# NET-ENERGY METERING 2.0 LOOKBACK STUDY

**Submitted to:**  
California Public Utilities Commission  
Energy Division

January 21, 2021

## APPENDIX B COMMENT MATRIX AND EVALUATOR RESPONSES

**FIGURE 3-12: RESIDENTIAL NEM SYSTEMS IN DISADVANTAGED COMMUNITIES**

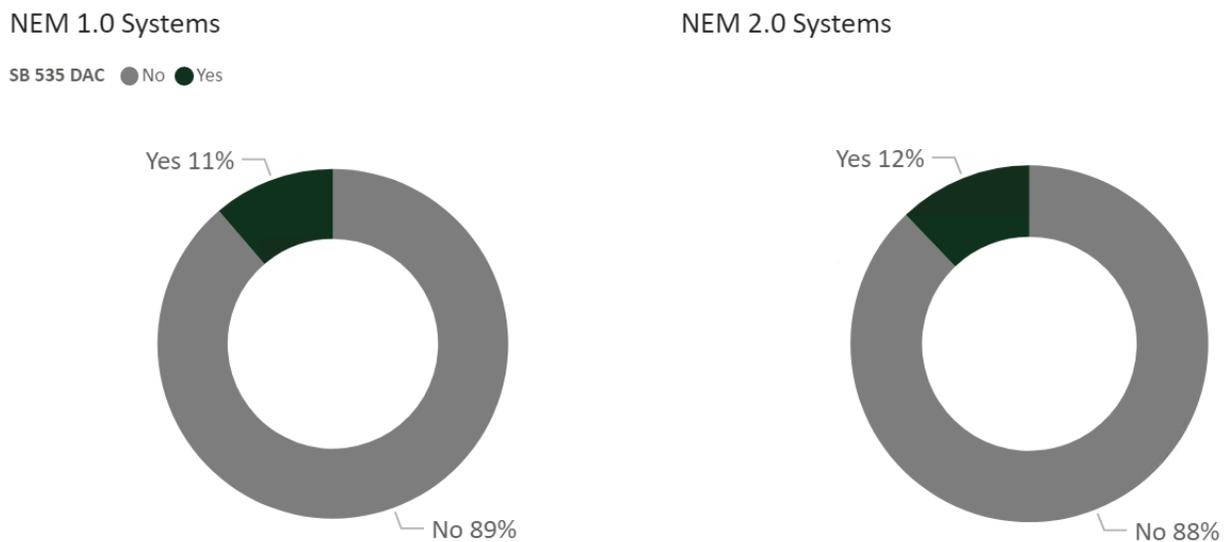
63	TURN	3-17	"Beginning in 2015 through 2019, the proportion of systems installed in DACs increased to 13 percent". Is the 13% figure the same as the 12% shown in Figure 3-12? It would be helpful to add text to the report describing why these figures differ, or correct the report, as appropriate.	This has been updated in the text to reflect 12 percent, thanks for pointing out this inconsistency.
64	TURN	3-15	It would be helpful if the report could provide additional DAC data. For example, percentage of home ownership for NEM 2.0 systems in DACs, the size of NEM 2.0 vs NEM 1.0 systems in DACs, and DAC NEM customer participation by successor tariff rate schedule.	These are all very interesting questions, and the distribution of DER systems in DACs deserves additional research. Unfortunately, it would require much finer data such as street addresses for NEM 2.0 customers that was not available to Verdant per NDA limits with the IOUs.

**FIGURE 5-9: RESIDENTIAL AGGREGATE FIRST YEAR BILL PAYMENT AND COST OF SERVICE PRE AND POST NEM 2.0**

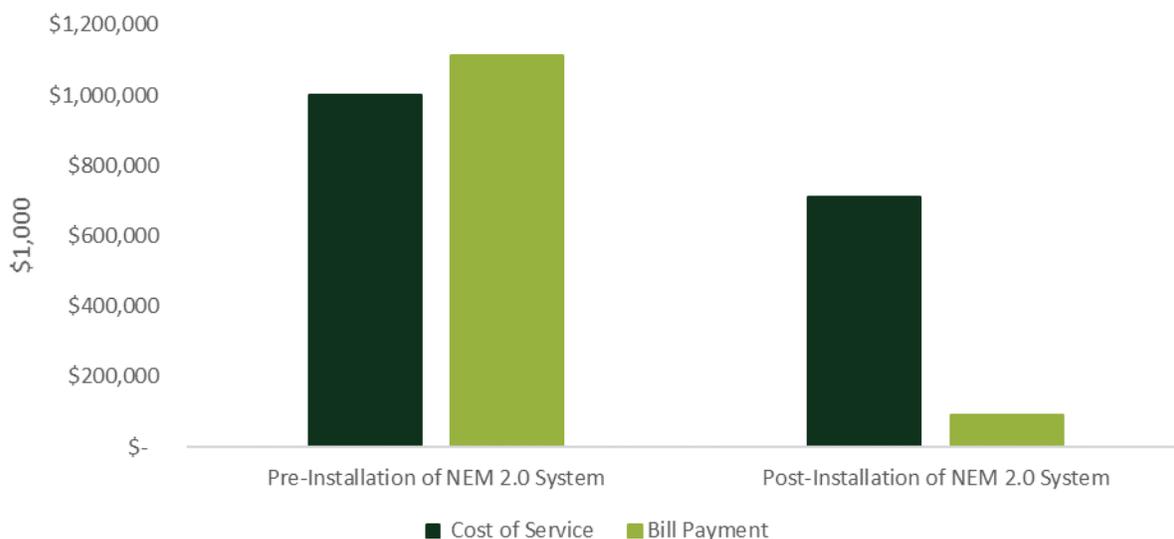
22	CALSSA	Figure 5-9	Verdant should also compare its modeled net surplus generation amounts with information from the utilities on how much net surplus compensation has been paid.	We assume this comment relates to the previous finding that average bills were at or near zero dollars for the year. We have made various changes to the model and customers on average to not utilize the NSC nearly as much as in the draft.
23	CALSSA	Figure 5-9	In the methodology, Verdant should break down its findings on total net generation/consumption per year, minimum bill payment, and Climate Credit payment for different customer segments.	We will expand the results section to describe the influence of the California Climate Credit and NSC.

**FIGURE 5-10: SHARE OF RESIDENTIAL AND NONRESIDENTIAL NEM 2.0 SYSTEMS BY RATIO OF PV GENERATION TO CUSTOMER CONSUMPTION**

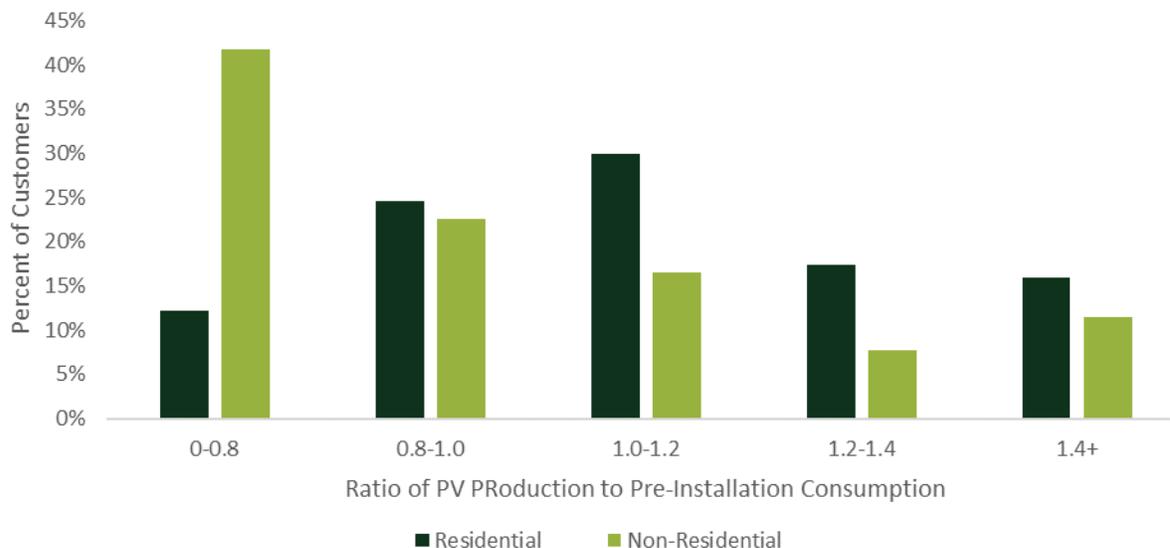
Comment #	Commenter	Page or "Overarching" for general comments	Comment/feedback/change requested	Evaluator's Response
65	TURN	5-19	Figure 5-10 indicates that more than 30% of residential customers and more than 20% of non-residential customers have at least 20% more PV generation than load. Similarly, Table 1-1 indicates that PG&E and SDG&E NEM 2.0 systems are sized on average to supply 112% of annual load. However, the NEM 2.0 tariff states that Generating Facilities that are sized larger than the Customer's electrical requirements are not eligible for NEM. If this issue has not been remedied with the correction that was made to generation output, it would be helpful to add an explanation regarding how these customers remain NEM eligible.	The model has been updated to use the post-installation net load plus the PV generation. The sections you reference will be updated, but it is still true that systems are being installed that exceed the customers pre-installation load. Customers are increasing their electricity consumption.
